# **Suffolk County Council (20031377)**

Answers to Examining Authority's Questions 2 (ExQ2)

## **Sunnica Energy Farm (EN010106)**

**Deadline 5**

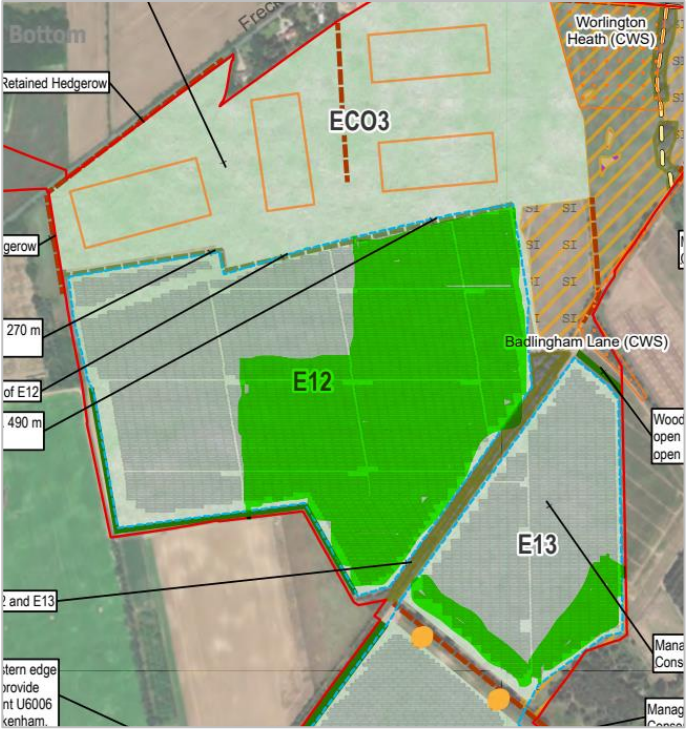
ExQ2	Question to:	Question:	SCC Answers:
Q2.0.9	SCC	<p><b>Land parcels E12, E13, E05</b></p> <p>If the ExA were to recommend that parcels E12, E13 and E05 should remain, please identify the extent of the PV solar panels in those parcels that would effectively mitigate impacts.</p>	<p><b>E12</b></p> <p>The Councils strongly consider that to “effectively mitigate impacts” E12 should be omitted from the scheme as stated in the LIR (8.6 bullet 2, 8.57, 10.175, 10.203, 10.204, 10.205), however the following reduction in solar panels (see Figure 1) would reduce those impacts to <u>some</u> degree that would be meaningful in terms of landscape impact but would still leave residual impacts to be compensated or offset in some other way.</p> <ul style="list-style-type: none"> <li>• Provide an appropriate set back from U6006 to reduce the visual impact of having panels on both sides of the route. Please see Figure 1 showing E12, below.</li> <li>• Allow further screen planting along the boundary of E12, including with ECO3, which should be limited to a hedge.</li> <li>• Require cable crossings across the U6006 to be drilled rather than trenched to retain existing trees and minimise effects.</li> <li>• Enable the reduction of visual impacts in landscape terms on users of the U6006 road without increasing the impacts on ecology.</li> </ul> <p>The following residual issues would persist:</p> <ul style="list-style-type: none"> <li>• Because construction and operational access to E12 is restricted by ECO3, one crossing across U6006 would remain, with unacceptable impacts on TPO trees which form part of a pine line (G81-avenue of Scots pine and G82q dense group of oak, hawthorn, blackthorn, elm, AIA [REP3-021] p40 and TPP sheet 14). This could not be effectively mitigated.</li> <li>• The residual panels within E12 would continue to impact on Stone Curlew that</li> </ul>

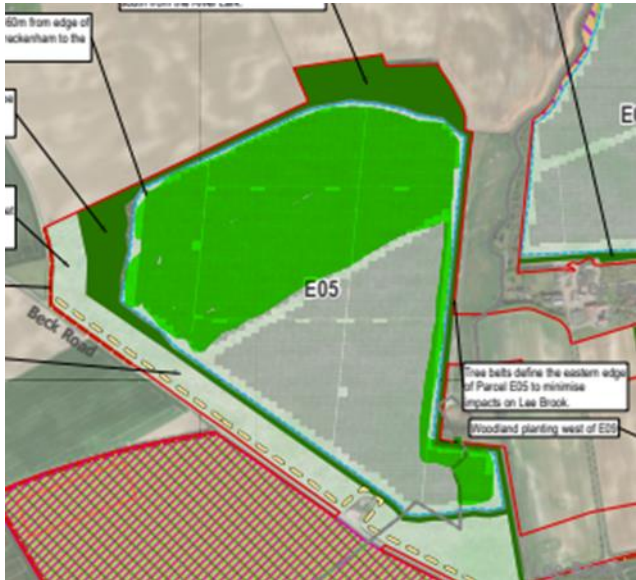
ExQ2	Question to:	Question:	SCC Answers:
			<p>sheet 14). This could not be effectively mitigated.</p> <ul style="list-style-type: none"> <li>The residual panels within E13 would continue to impact on Stone Curlew that have nested E13.</li> </ul>  <p><b>Figure 1:</b> Showing the solar panels to be removed from E12 and E13 shaded in light green</p> <p><b>E05</b> The Councils' preferred option is to apply the mitigation hierarchy and avoid harm, by removal of E05 as stated in SCC post hearing submission [REP4-124], in the LIR ([REP1-024] paras 8.6 bullet 2,</p>

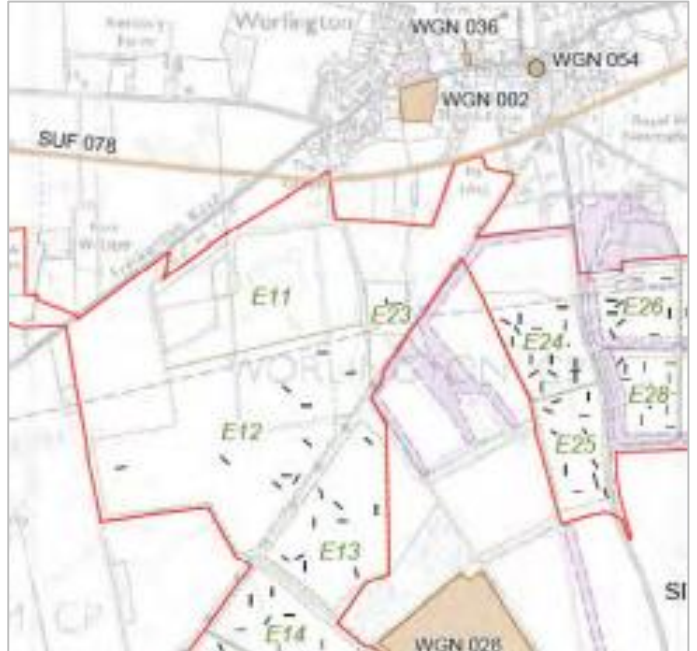
ExQ2	Question to:	Question:	SCC Answers:
			<p>the concern that there are potentially conflicts in managing the area for both archaeology and for Stone Curlew.</p> <p>Natural England's guidance on the provision of Stone Curlew mitigation is set out in the advice note 'Sourcing and managing mitigation land'. This explains that 'Stone Curlew generally nest in open fields with dry soil, with areas of dry, bare, stony ground or low vegetation'. The guidance sets out how stone curlew offsetting land can be established and managed. West Suffolk Council have submitted a copy of this guidance with their submission.</p> <p>Aspects of the stone curlew offsetting which have the potential to cause conflict with preservation and management of archaeological interest include:</p> <ul style="list-style-type: none"> <li>• Reduction of nutrient levels prior to the establishment of grassland</li> <li>• Establishment of grassland</li> <li>• Management of bare ground nesting plots</li> <li>• Management/grazing of grassland</li> </ul> <p>The archaeological requirements /constraints include:</p> <ul style="list-style-type: none"> <li>• Disturbance or intrusion of the topsoil must be minimised/avoided including topsoil removal or inversion</li> <li>• Additions to the existing topsoil can alter the PH of the soil and harm buried archaeology. This includes chemicals which should be minimised</li> <li>• Cultivation of topsoil is limited to disc harrowing or drilling, and ploughing should be avoided</li> </ul>

ExQ2	Question to:	Question:	SCC Answers:
			<ul style="list-style-type: none"> <li>• The grassland should be a closed grass sward maintained to prevent scrub development</li> <li>• Bare ground should be avoided to prevent wind blow which might expose buried archaeology</li> <li>• Disturbed ground plots can be delivered where trial trenching has demonstrated that buried archaeology is not present. Areas where trial trenching has been undertaken is illustrated at Annex 3 - 6.2 Appendix 7H: Sunnica East Sites A and B Archaeological Trial Trenching Report [PDA-002]</li> <li>• Grassland maintenance could include grazing by sheep or mechanical topping/mowing</li> <li>• Grazing by rabbits must be avoided because of the disturbance rabbits cause.</li> </ul>
